MPC8308 Chip Errata

This document details all known silicon errata for the MPC8308. The following table provides a revision history for this document.

Figure 1. Recommended connections for DDR controller and memory

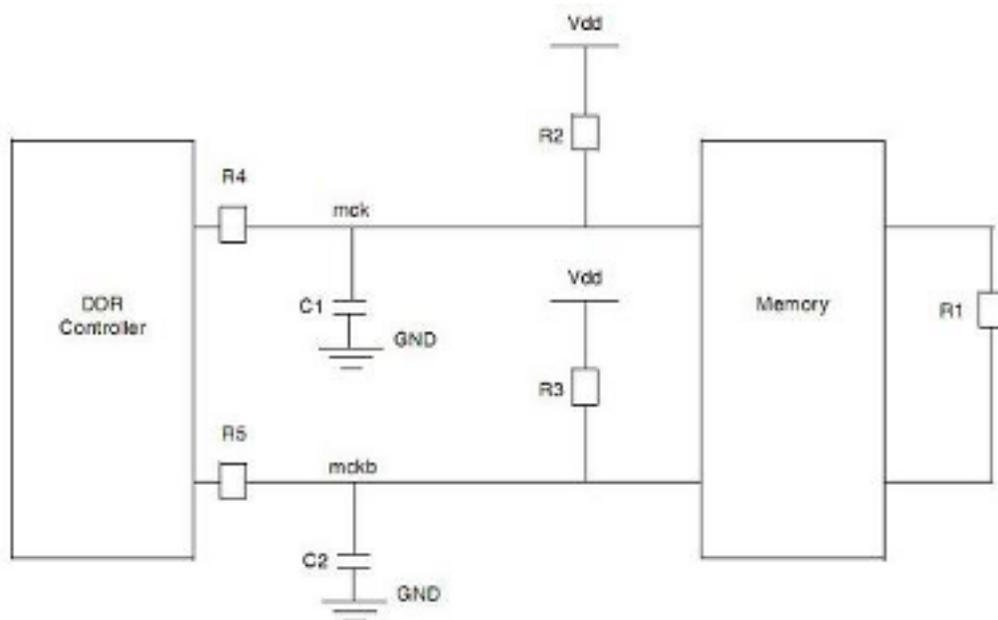
DDR21: MCK/ $\overline{\text{MCK}}$ AC differential crosspoint voltage outside JEDEC specifications

Description: The crossover points of the MCK and $\overline{\text{MCK}}$ signals of the DDR controller are not meeting JESD79-2C specifications, which indicates that the crossover points should lie within ± 125 mV range of reference voltage.

Workaround: To meet the JESD79-2C crosspoint voltage specifications, we recommend implementing the following connections between the DDR controller and DDR2 memory:

Effect of different circuit components on MCK and $\overline{\text{MCK}}$ signals:

1. Increasing R2 and R3 shifts signal levels up (used as pull up).
2. Increasing C1 increases rise/fall time of mck signal.
3. Increasing C2 increases rise/fall time of mckb signal.
4. Reducing R1 can help in shifting the signals up.
5. R4 and R5 can be used to make termination proper.

Component Placing:

R4, R5, C1, C2 near to SOC, R1, R2, and R3 have been placed at the end of clock transmission lines.

By considering these suggestions and choosing proper values of components for a particular board layout, one can keep crossover points within range.

We recommend varying termination resistor R1 first. Lowering R1 can help increase the voltage levels up. The only disadvantage is that it may add up more reflections. Therefore, the user must decide accordingly. If it does not give sufficient margin, the user can add the pull-up resistor (R3 and R4) option to further increase the voltage levels.

Exact values of components vary from design to design and some of them may not be required for all designs. We recommend that you make provisions for all these options in your design.
